**Public Service Company of Colorado**  
5909 East 38th Avenue, Denver, Colorado, 80207

June 7, 1982  
Fort St. Vrain  
Unit No. 1  
P-82184

Subject: Electrical Power Systems

### Documentation of Voltage Studies

FIGURE 5- GRID VOLTAGE AT LOWEST EXPECTED VALUE 226KV CONCURRENT WITH STARTING OF BFP. BASE VOLTAGE = 480 V

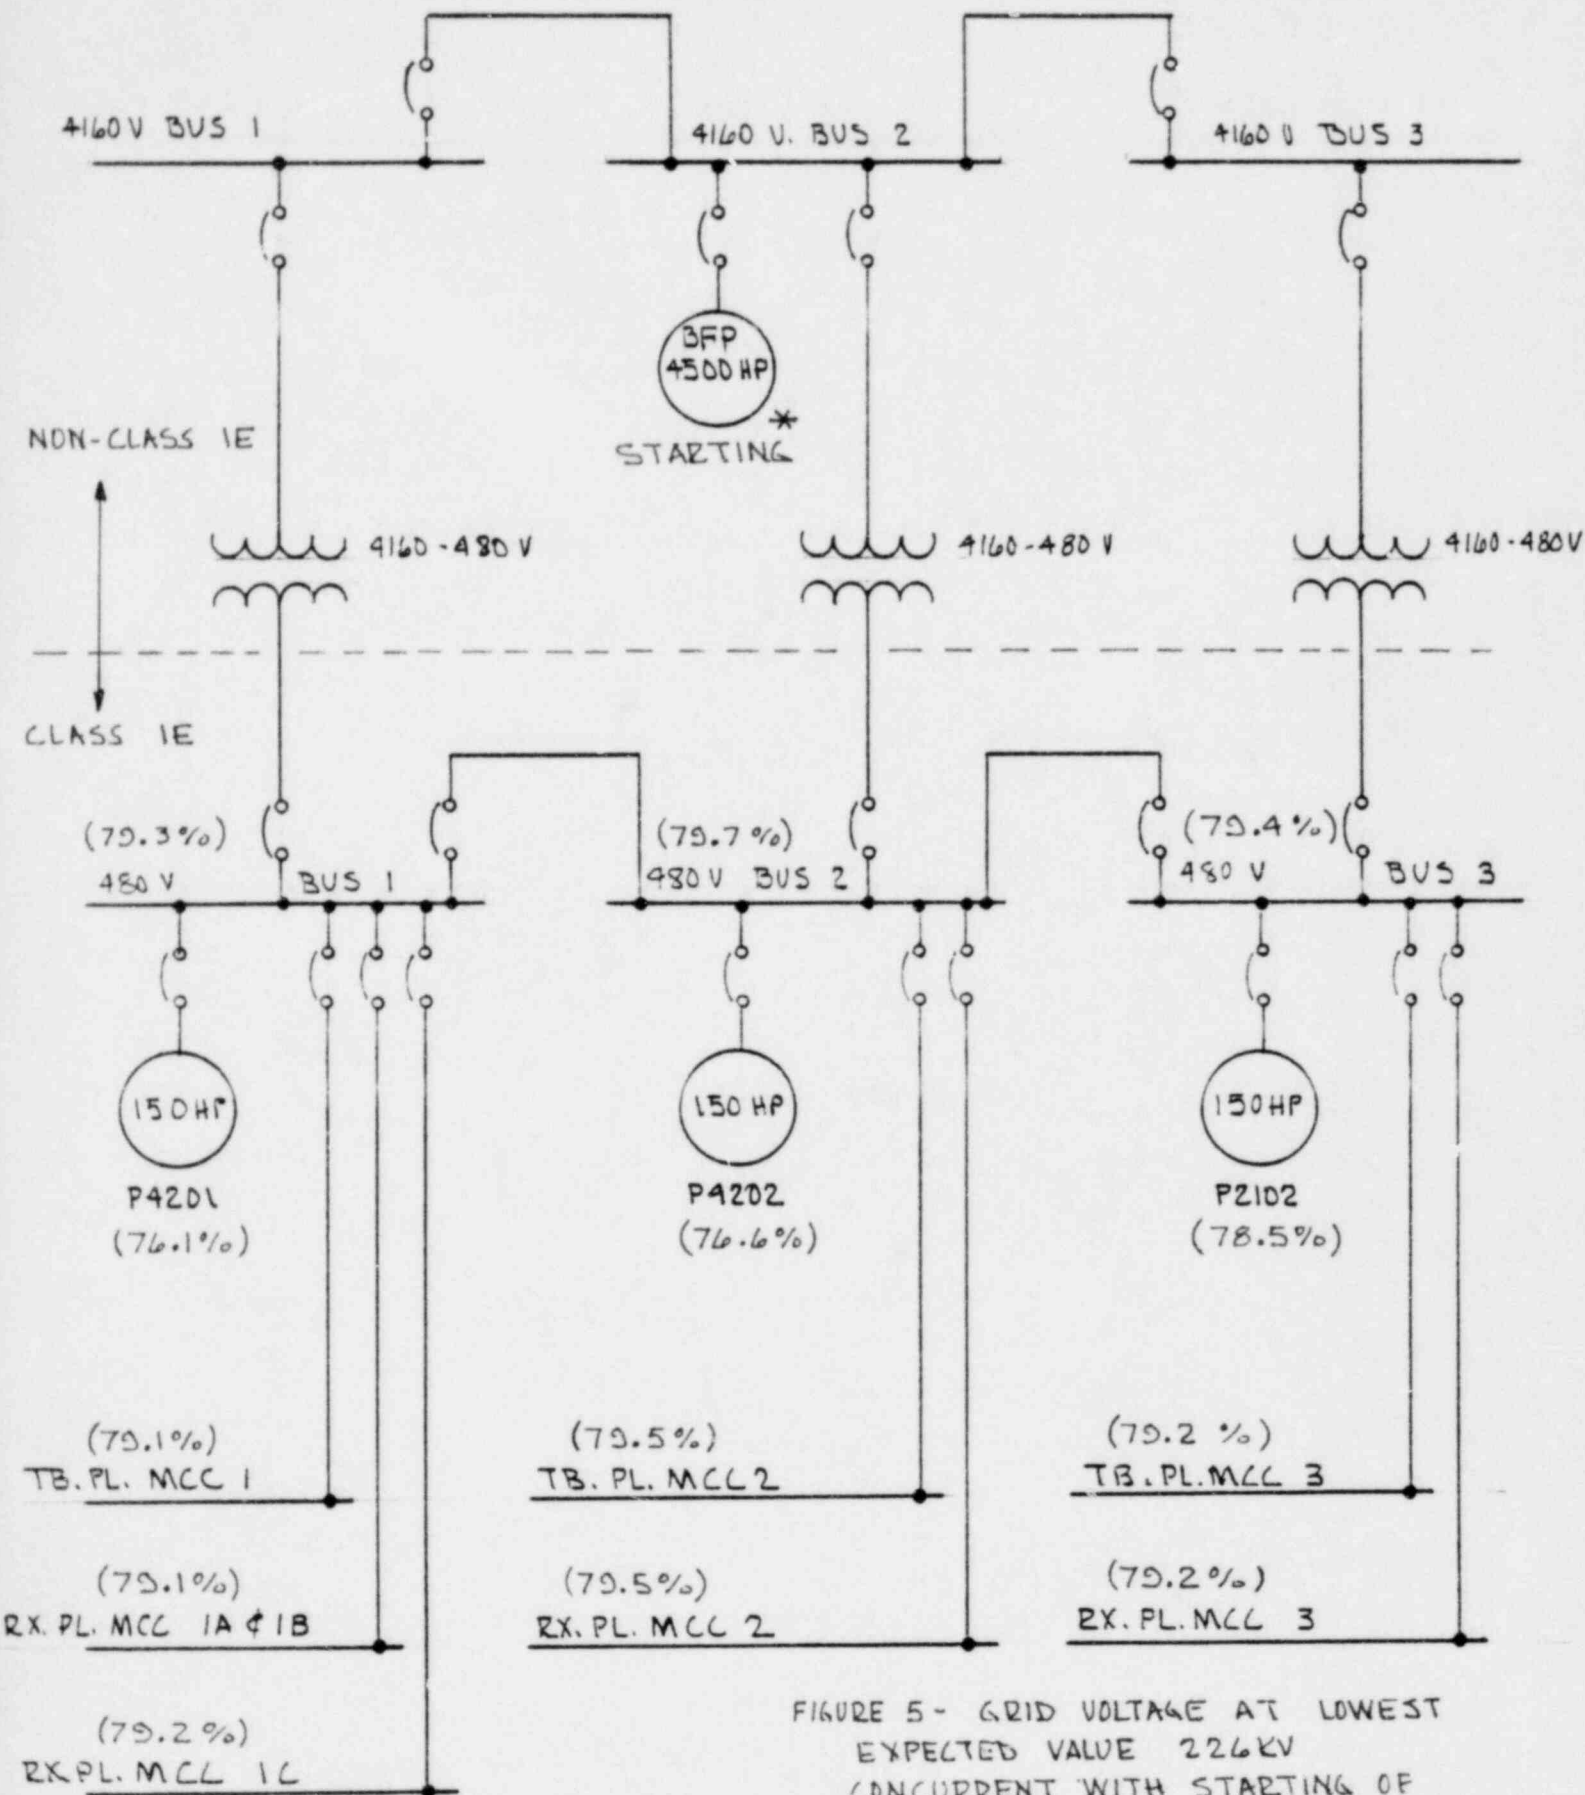
The voltage analysis should include documentation for each condition analyzed of the voltage at the input and output of each transformer and at each intermediate bus between the connection to the offsite circuit and the terminals of each safety load.

Figures 5 and 6 provide data from the analytical studies for the high and low voltage situations.

For the low grid voltage case the manual starting of the 4500 HP Boiler Feedpump was assumed. Approximately the same loads will be in service regardless of whether the proposed start occurs during routine plant startup or if the start occurs following a unit trip.

Figures 5 and 6 provide this information for the safety-related buses. High and low voltage situations are presented.
